UNITED STATES PATENT AND TRADEMARK OFFICE

APPLICATION NO.	FILING DATE	FIRST NAMED INVENTOR	ATTORNEY DOCKET NO.	CONFIRMATION NO.
10/573,618	03/27/2006	Hartmut Nitzsche	101914450	9019

Office Action Summary

DETAILED ACTION

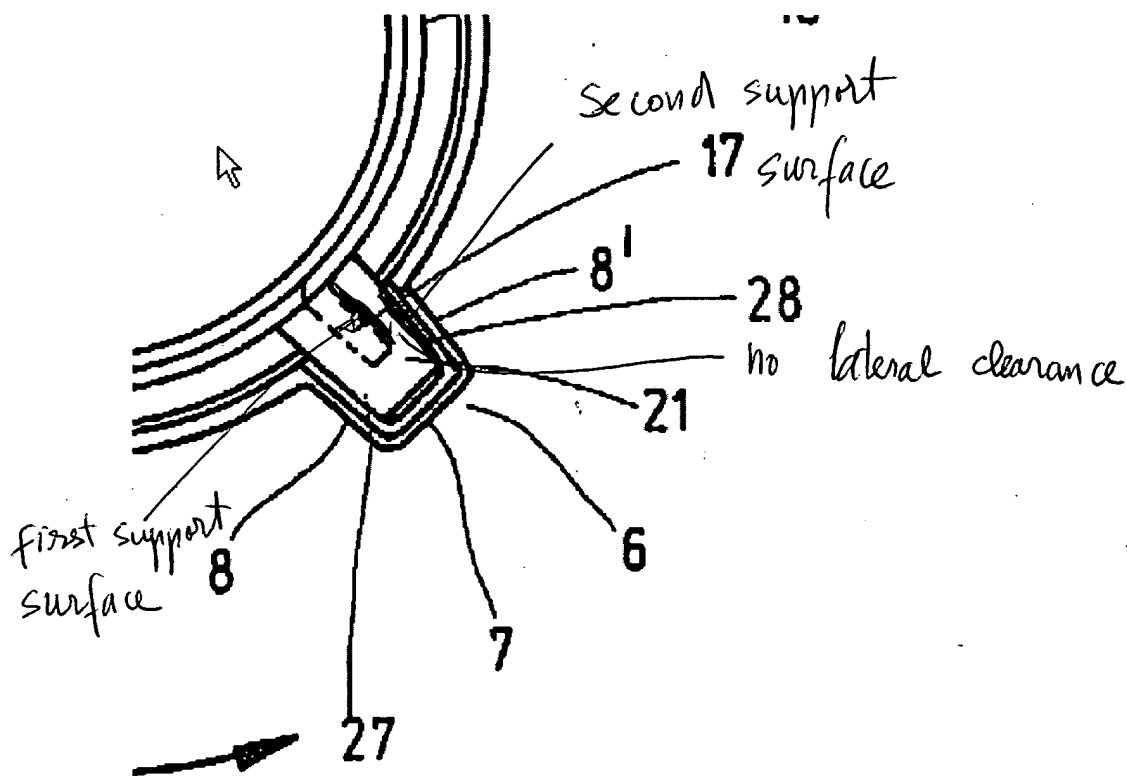
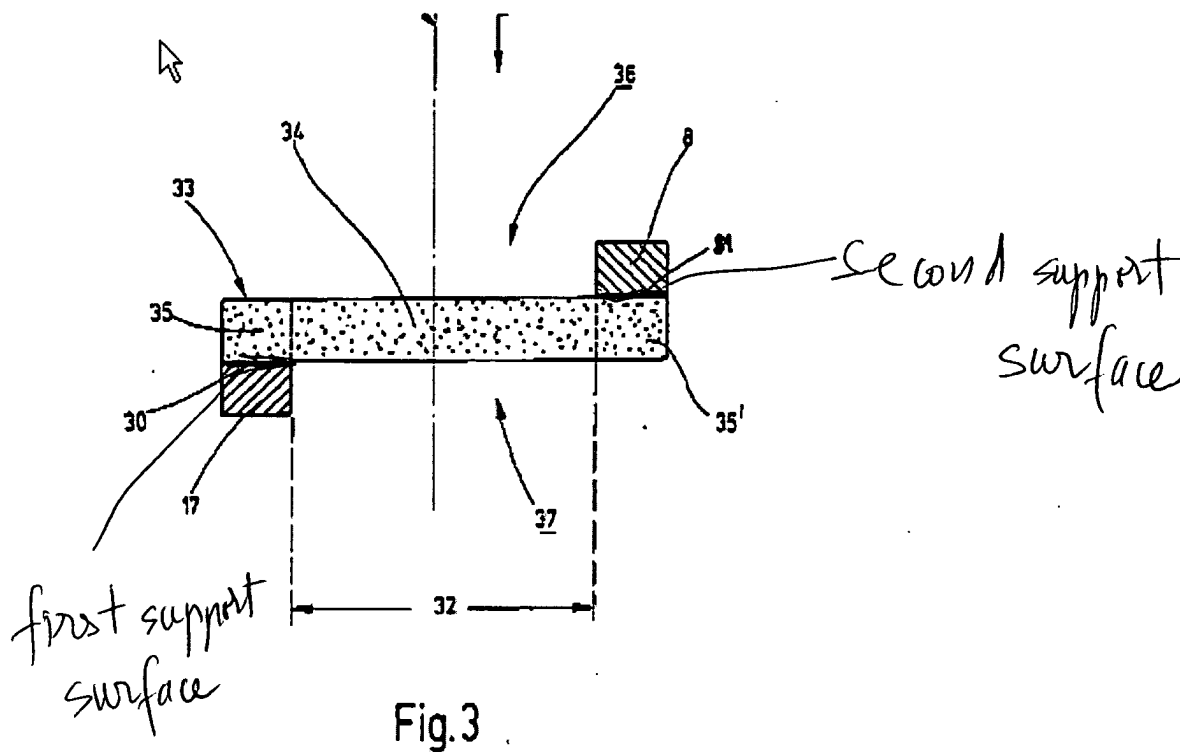
Regarding claim 17, the limitation "the at least one first support surface and the at least one second support surface have a lateral clearance from each other" and "the at least one first elastic element bridges the lateral clearance in the form of a first free bridge" is not understood by an ordinary skill in the art.

Figures 1, 2 show holding tab 17 formed on the stator frame of motor 12. Holding tab 17 is covered on two sides by damping element 21 as shown in Fig. 1. The side wall 28 of damping element 21 is between holding tab 17 and pocket side wall 8'. As best understood by the Examiner and shown in Fig. 3, the first support surface 30 is the surface of the overlapping region of the holding tab 17 and elastic member and the second support surface 31 is the overlapping region of the pocket side wall 8' and the elastic member. However, as shown in Fig. 2, there is no lateral clearance between first support surface 30 and the at least one second support surface 31 and the disclosure does not show how the lateral clearance 32 is formed in Fig. 3. Fig. 4 shows an embodiment quite different from Fig. 2 with two holding tabs 17 on one side of the elastic member and pocket side wall 8' on the other side.
